Wheels & Brakes

SERVICE BULLETIN

CONVERSION OF P/N 40-75P WHEEL ASSEMBLY TO P/N 40-406 CONFIGURATION

Figure 1

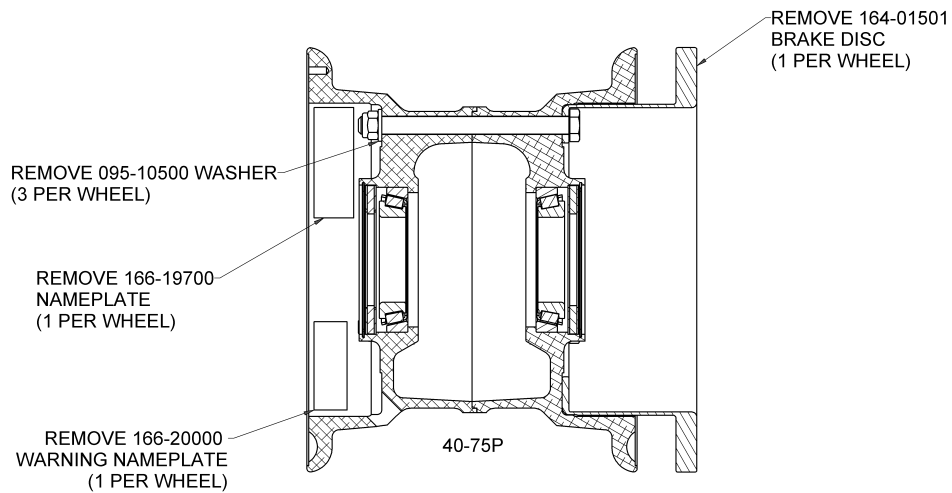
- 1) For new wheels that have not been in service, proceed to step 3.
- 2) Jack aircraft, **DEFLATE** tire and remove valve core, remove wheel IAW Cirrus Design Aircraft maintenance procedures, disassemble wheel, and thoroughly inspect the wheel halves and components (except as noted in Table 2) for airworthiness IAW Parker AWBCMM0001-6 Component Maintenance Manual.
- 3) **DEFLATE** tire and remove valve core, remove and discard the hardware and nameplates as shown in Figure and 1listed in Table 2 below.

The following components must be removed from the existing P/N 40-75P wheel assembly and discarded. CAUTION: Do not use sharp tool to remove nameplate.

Figure 2

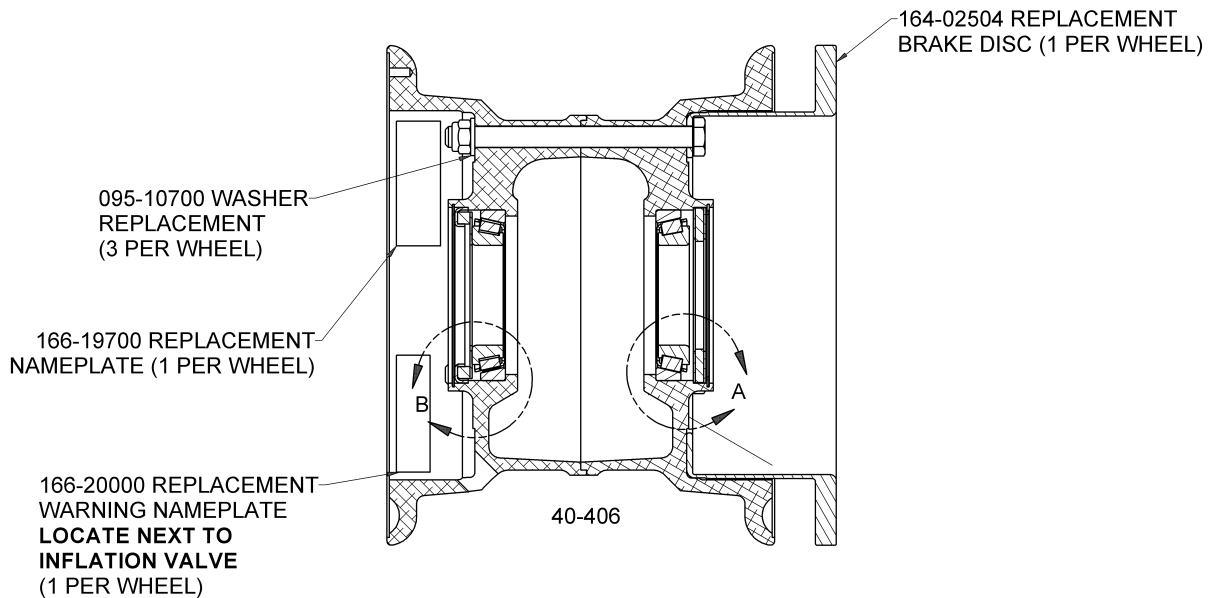
5) Assemble the wheel-tire assembly with the hardware furnished in SB7085-1 Conversion Kit, (Table 1) IAW Parker AWBCMM0001-6 Component Maintenance Manual and as shown in Figure 2.

6) Apply replacement nameplate, P/N 166-19700, on outboard wheel half opposite inflation valve hole. Ref. Figure 2. (The manufacturing date code for all replacement nameplates will include "R" between the month and year that it is printed to indicate a replacement nameplate. A nameplate printed in February of 2006 will bear Mfg. Date of 02R06).

7) Apply P/N 166-20000 Warning Nameplate adjacent to the inflation valve hole, Ref. Figure 2. Do not apply over existing nameplate. (Two warning nameplates are permissible.)

Figure 3 (View A)
Inner grease seal configuration

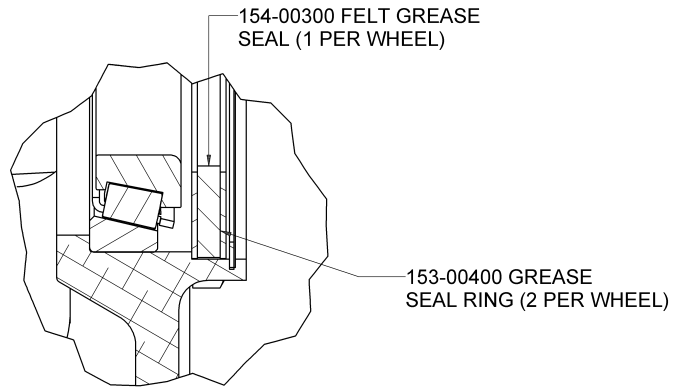
5b) Install grease seal rings P/N 153-00400 and grease seal felt P/N 154-00300 in inboard wheel hubs and secure with retaining ring P/N 155-00100. Install grease seal ring P/N 153-00300, grease seal felt P/N 154-01300, and grease seal ring P/N 153-01500 in outboard wheel hubs and secure with retaining ring P/N 155-00100. Ref. Figures 3 and 4. Torque wheel tiebolt system evenly to half the final torque then evenly to 150 in-lbs **DRY**.
